BID ADDENDUM NO. 4 ISSUED 4/24/2019

LIBRARY REMODEL AT NORDHOFF HIGH SCHOOL PROJECT NO. 2019-1714

ADDENDUM NO. 4

A-103

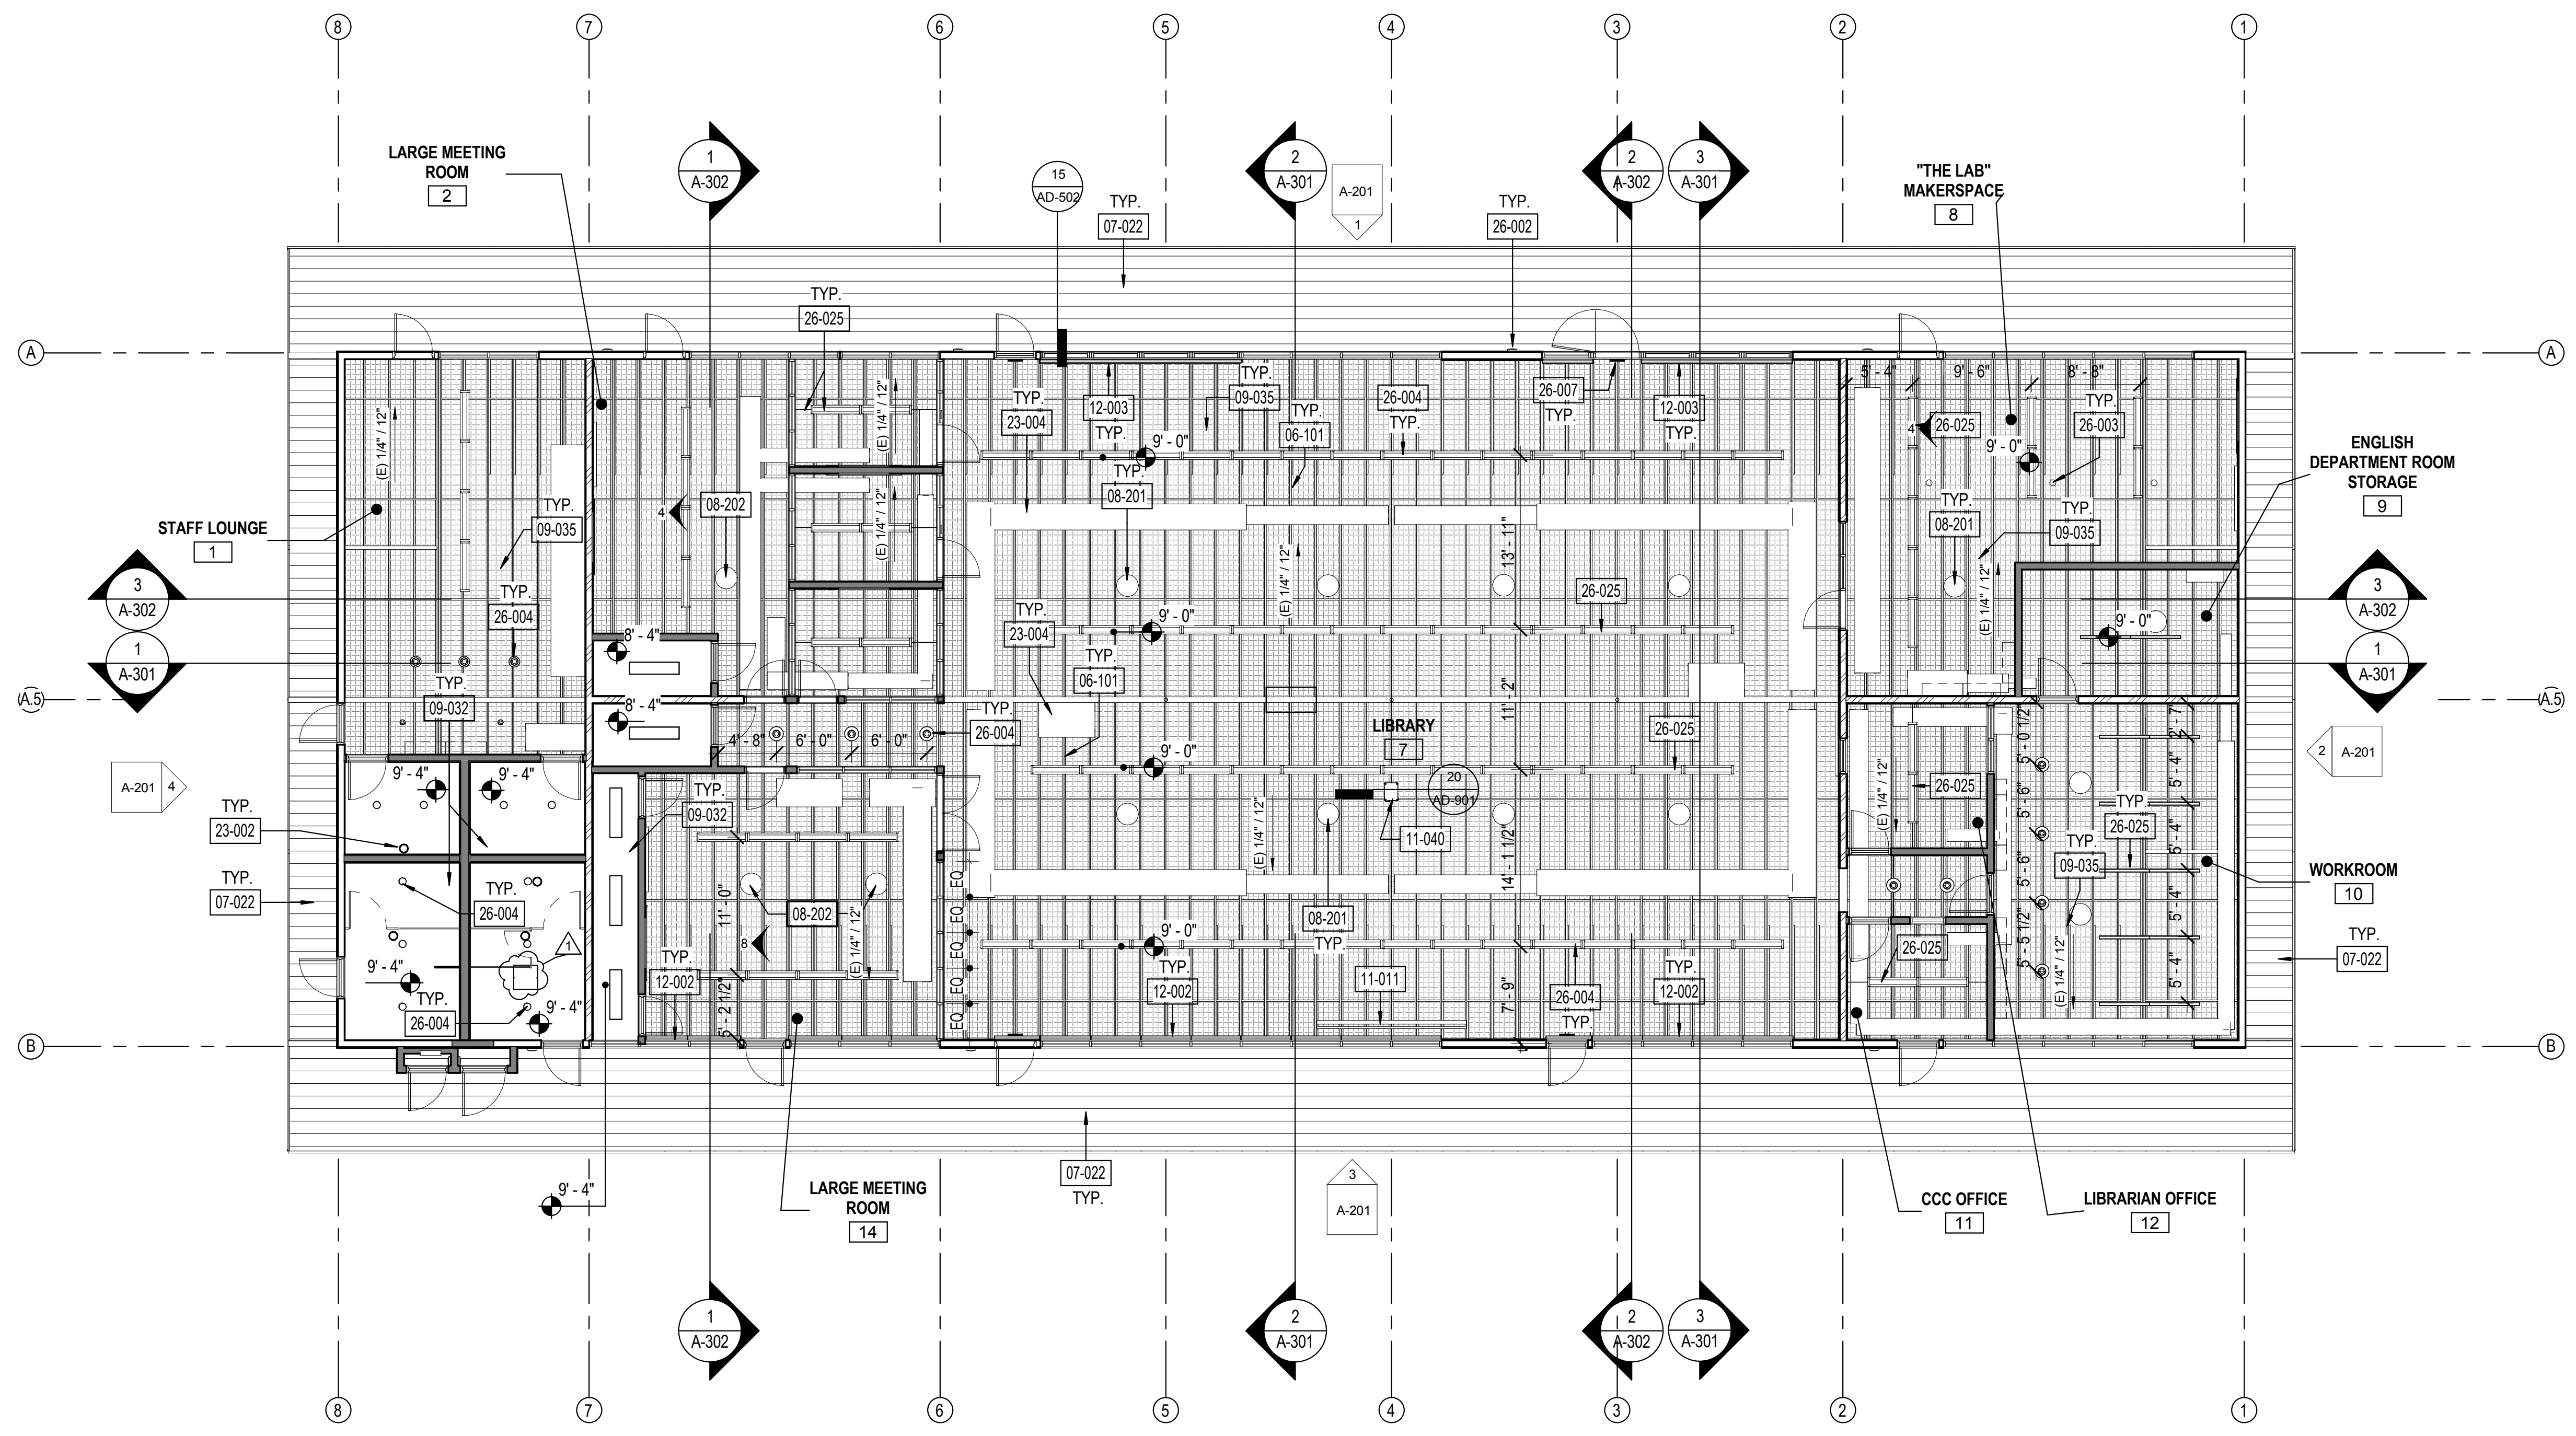
- Item 2 **AD-502 Roof Details** – Detail 10 revised to remove discrepancy with structural detail and show galvanization for frame.
- Item 3 **A-103 Reflected Ceiling Plan** – Drawing revised to coordinate with roof plan for tubular skylight located in Girls Restroom [19].

5	There is a discrepancy between the quantity of Solatube Skylights shown on A-102 and A-103. A-102 shows two (2) skylights that are not shown on A-103. Please clarify the correct quantity of skylights and if A-102 is correct please clarify if each of the two skylights shown on A-102, and not on A-103, are either with Daylight Dimmer Kit or without.	The RCP has been revised to show a ceiling diffuser in the Gir's Restroom [19]. The tubular skylight in the English Department Storage Room [9] was shown on the plans, but there is no ceiling, so no separate ceiling diffuser. No Daylight dimmer kit provided for these two locations.	RNT
6	Is a 3rd party consultant required during asbestos and lead paint removal? If so, what are the requirements?	An EPA certified contractor is required as indicated in the contract language.	District
7	Please provide a spec for "Library" sign on the front of the trellis	The signage is to be painted steel.	RNT

MECH. SCREEN @ ROOF 1" = 1'-0" **10**

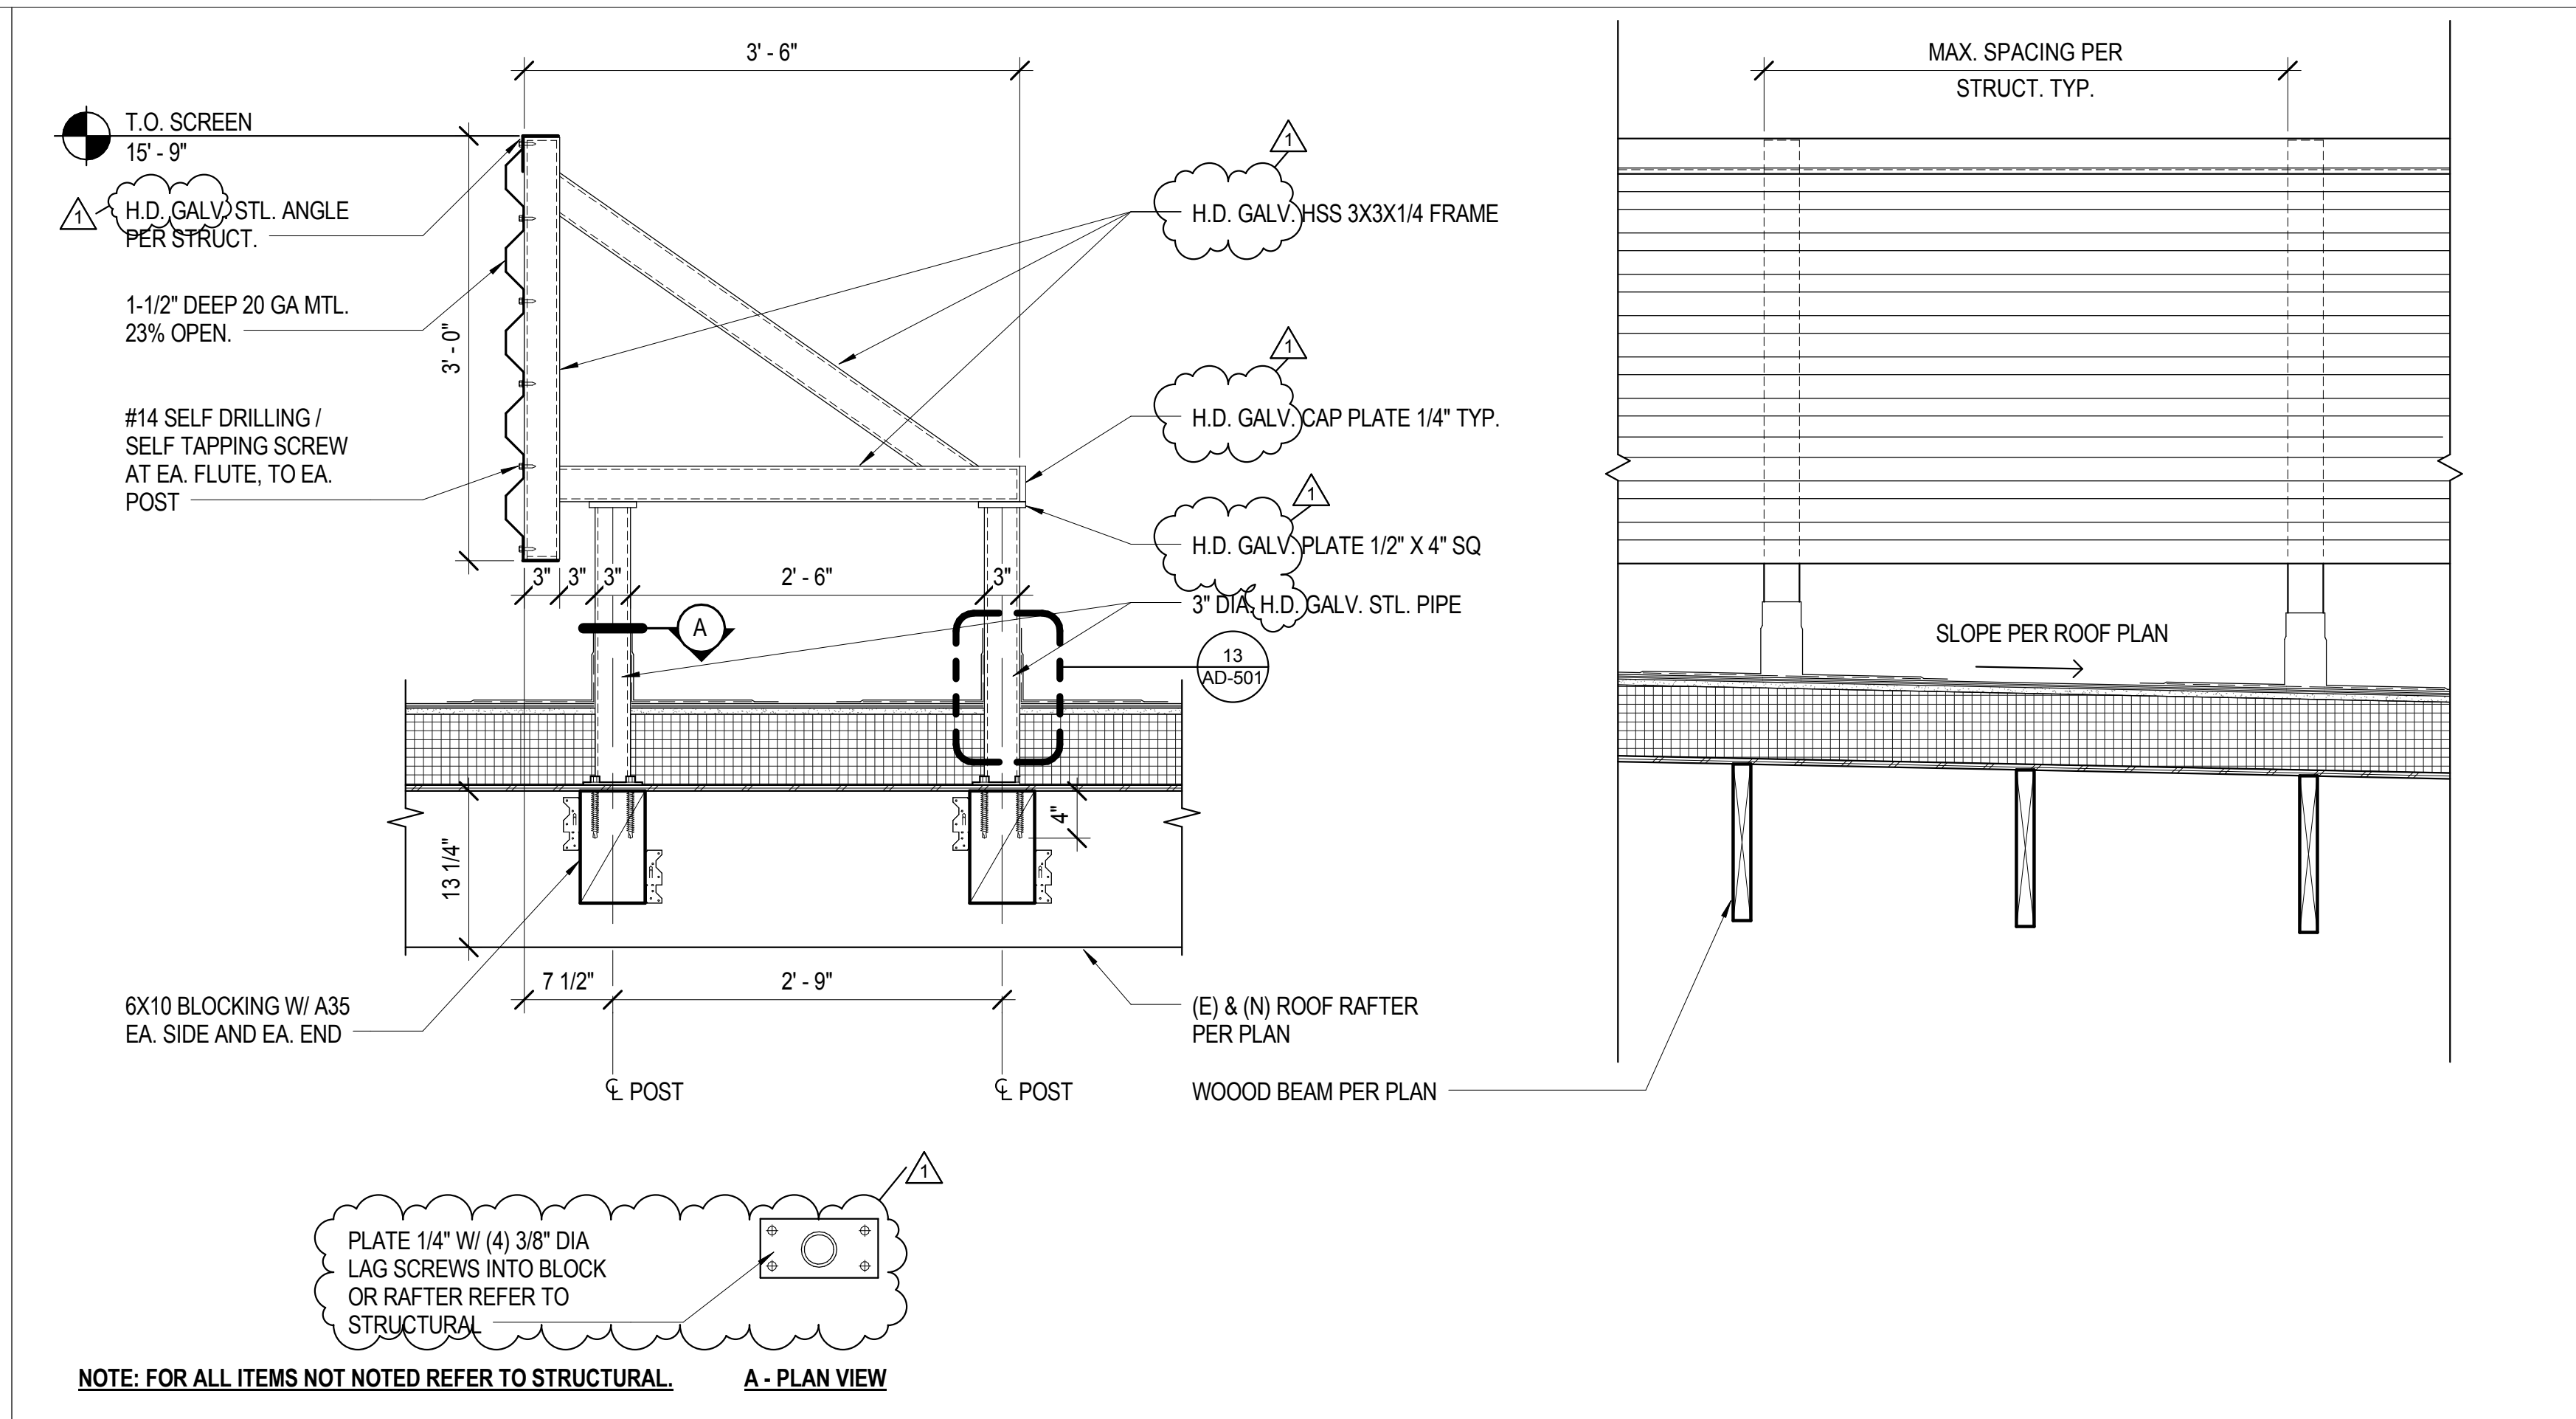
3	Detail 10/AD-502 indicates that the 3” dia. pipes in the roof screen framing are to be galvanized, but does NOT indicate that the HSS frames are to be galvanized. Please confirm that the HSS frames in the roof screen framing are NOT galvanized, or advise otherwise.	The roof screen frame should all be hot-dip galvanized. Detail 10/AD-502 revised accordingly. The metal panel finish is indicated in the specification.	RNT
4	There is a discrepancy in the size of the roof screen base plates shown in the two details	The Structural detail takes precedence. AD-502 revised to	RNT

referenced above. 10/AD-502 shows a ¼"x5"x8" plate while 1/S-600B shows a ¼"x5"x10" plate. Please clarify the size of the base plates.

remove discrepancy.
